## MONTEREY COUNTY PLANNING COMMISSION

| <b>Project Description:</b> Combined Development Permit as an after-the-fact permit consisting of:<br>1) Coastal Development Permit allowing bluff stabilization/erosion control to prevent structural damage from tidal erosion of terrace deposits and overlying soils. The artificial rock fascia is designed to match the existing shoreline contour, texture and color; 2) a Coastal Development Permit to allow development within 100 feet of environmentally sensitive habitat; 3) a Coastal Development Permit to allow development on slopes of 30% or greater; and 4) a Coastal Development Permit for development within 750 feet of a known archaeological resource. |  |
| <b>Project Location:</b> 3158 17-Mile Drive in the Del Monte Forest area of Pebble Beach  | <b>APN:</b> 008-491-013-000                            |
| <b>Planning File Number:</b> PLN100670  | <b>Owner:</b> Peter Read<br><b>Agent:</b> John Bridges |

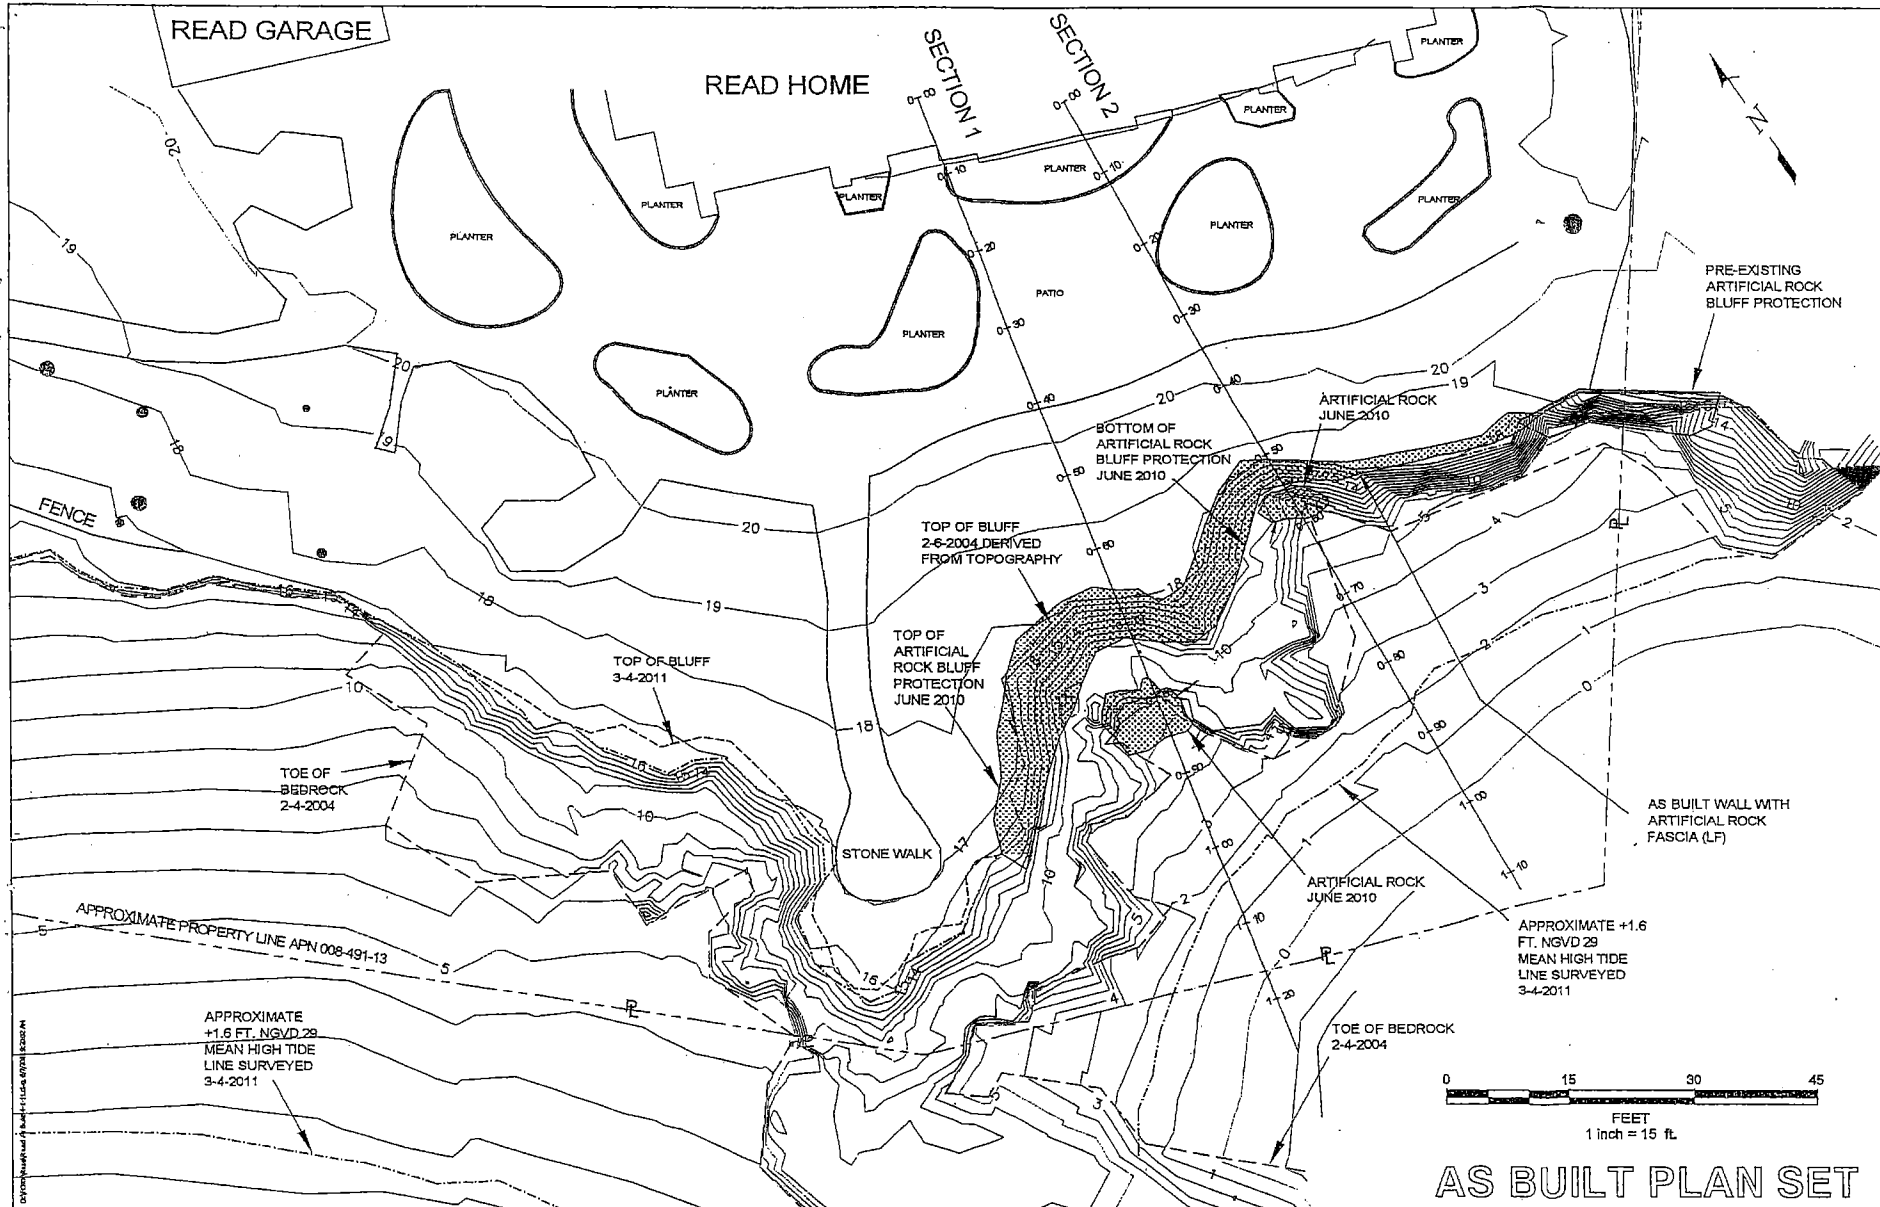
As shown on Sheet 2 of the Bluff Protection Plans the erosion control fascia is typically 20 to 25 feet landward of the surveyed MHTL, with the closest point being 16 feet from the surveyed MHTL. We were present at the site during the MHTL field survey. The beach area where the MHTL was surveyed consisted of bedrock, small boulders and cobbles at the time of the survey.

SECTION 1

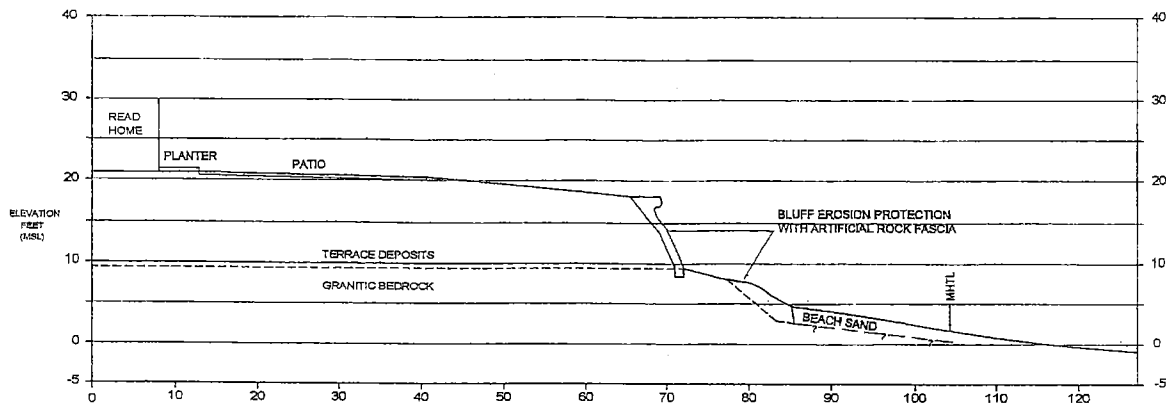
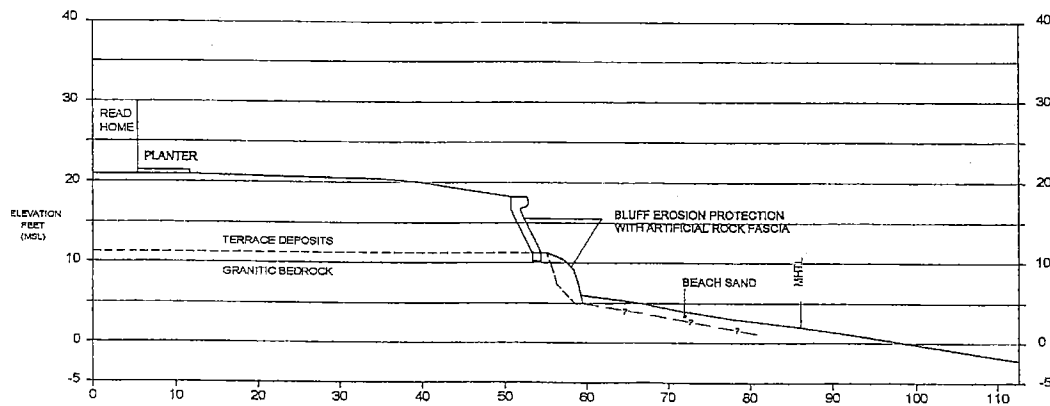
We reviewed the cross sections on Sheet 3 of the Read Property As Built Bluff Protection Plans, dated 4/1/2011 and the lowest portion of the erosion protection fascia meets the beach profile above elevation +4 NGVD. This in a location well landward of the MHTL position, the location of which is indicated on the cross sections.

Figure 5. Projected 50, 75, 100 - year erosion lines from top of coastal bluff, from Nielsen and Associates (2004)

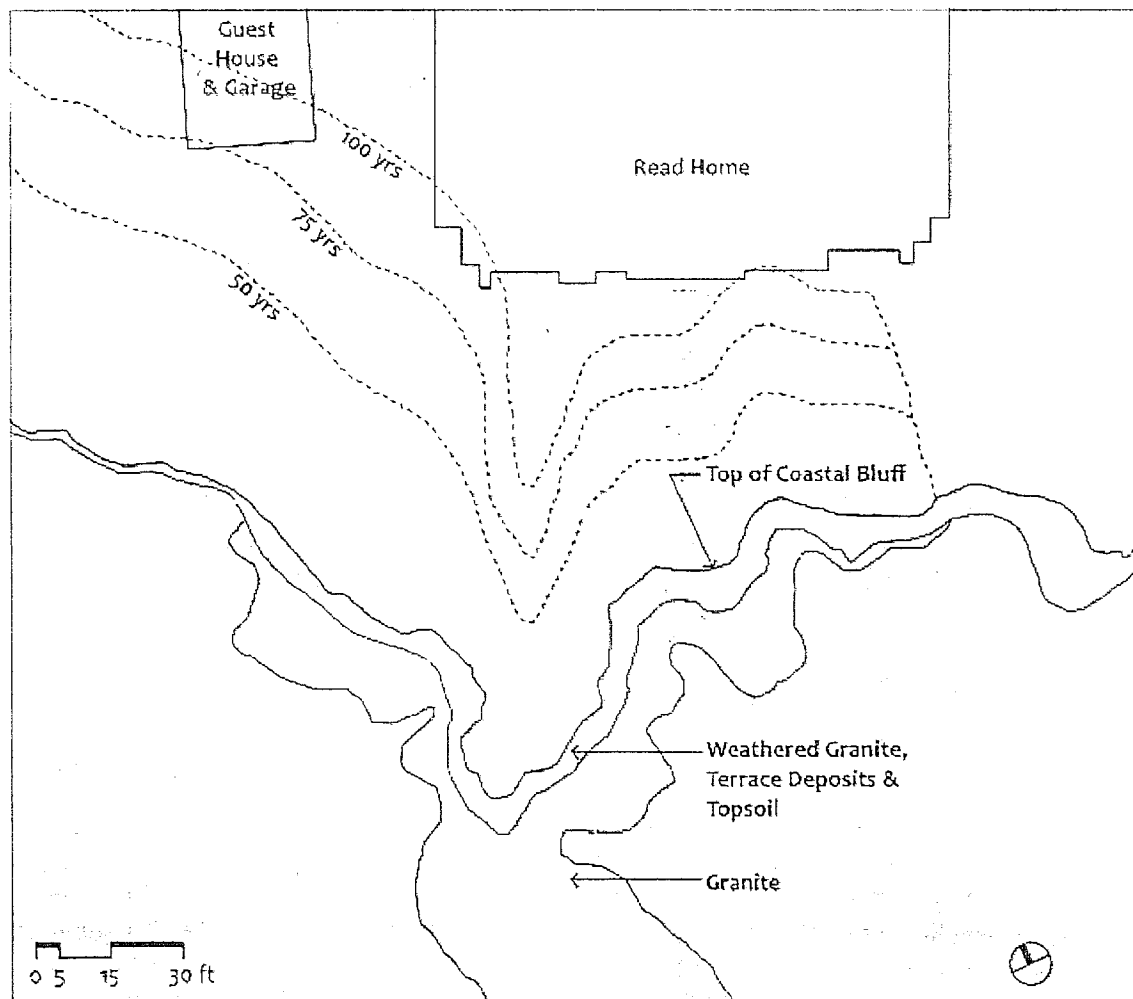
project alternative). Even with the new estimated rate of erosion of 0.5 feet per year, the Read home is not "in danger" from erosion as defined by the LCP or Coastal Act. From examination of Figure 5 in Dr. Griggs' report (which illustrates the projected 50, 75, and 100 year erosion lines of the bluff from an analysis done by Nielsen and Associates (2004) which assumed a bluff erosion rate between 0.45 and 0.75 feet per year) it appears that the Read home, guest house, and garage would be safe for another 50 years, and therefore these structures are not in imminent danger from erosion. In addition, Figure 5 also suggests that the portion of the bluff that would intersect the Read guest house within 75 years is located at the western property end, and not the southern end of the property where the bluff has been armored. If the property owner plans to protect his home from bluff erosion occurring on the western end of the property, then this would suggest that future bluff protection may need to occur near Otter Cove in closer proximity to environmentally sensitive habitat areas (ESHA).

Figure 5. Projected 50, 75, 100 - year erosion lines from top of coastal bluff, from Nielsen and Associates (2004)

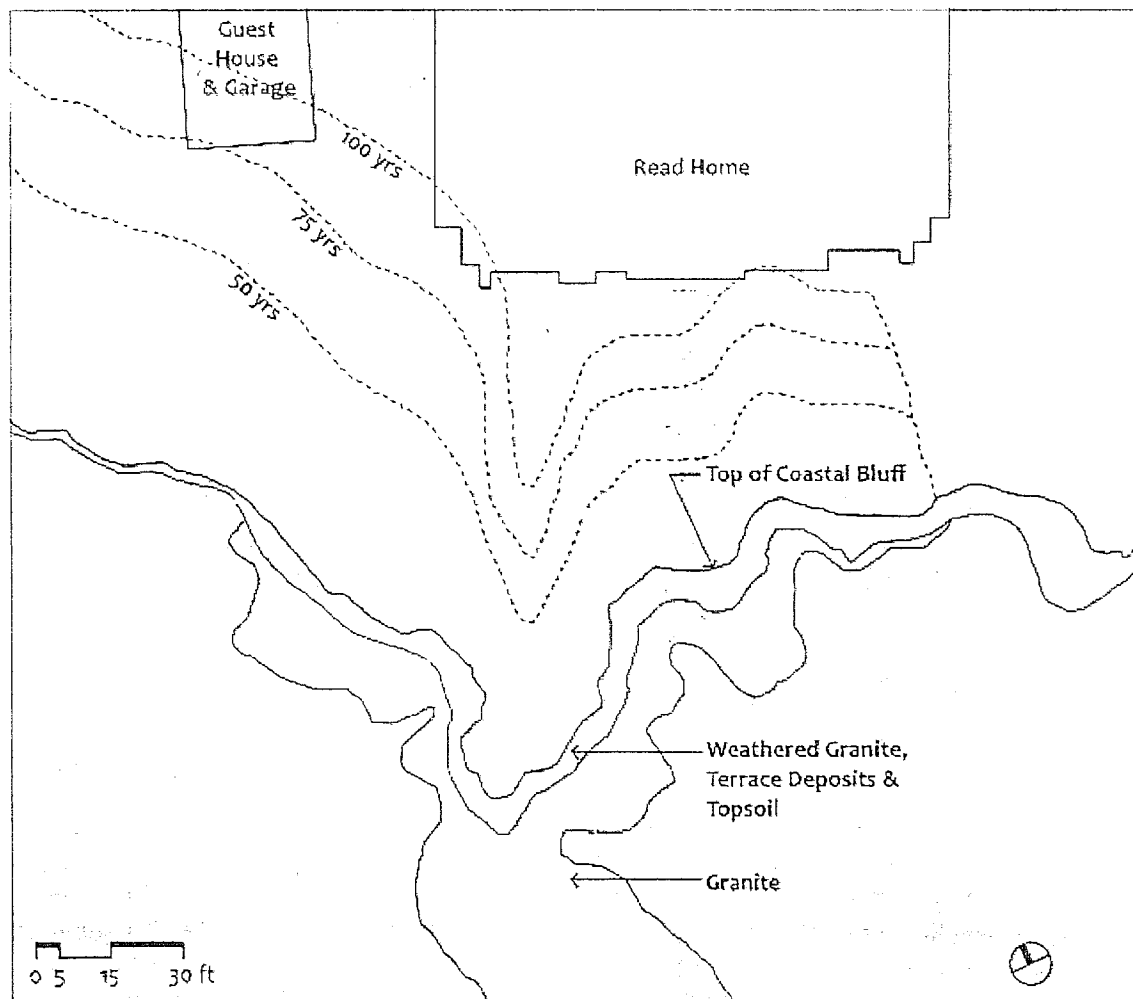
project alternative). Even with the new estimated rate of erosion of 0.5 feet per year, the Read home is not "in danger" from erosion as defined by the LCP or Coastal Act. From examination of Figure 5 in Dr. Griggs' report (which illustrates the projected 50, 75, and 100 year erosion lines of the bluff from an analysis done by Nielsen and Associates (2004) which assumed a bluff erosion rate between 0.45 and 0.75 feet per year) it appears that the Read home, guest house, and garage would be safe for another 50 years, and therefore these structures are not in imminent danger from erosion. In addition, Figure 5 also suggests that the portion of the bluff that would intersect the Read guest house within 75 years is located at the western property end, and not the southern end of the property where the bluff has been armored. If the property owner plans to protect his home from bluff erosion occurring on the western end of the property, then this would suggest that future bluff protection may need to occur near Otter Cove in closer proximity to environmentally sensitive habitat areas (ESHA).
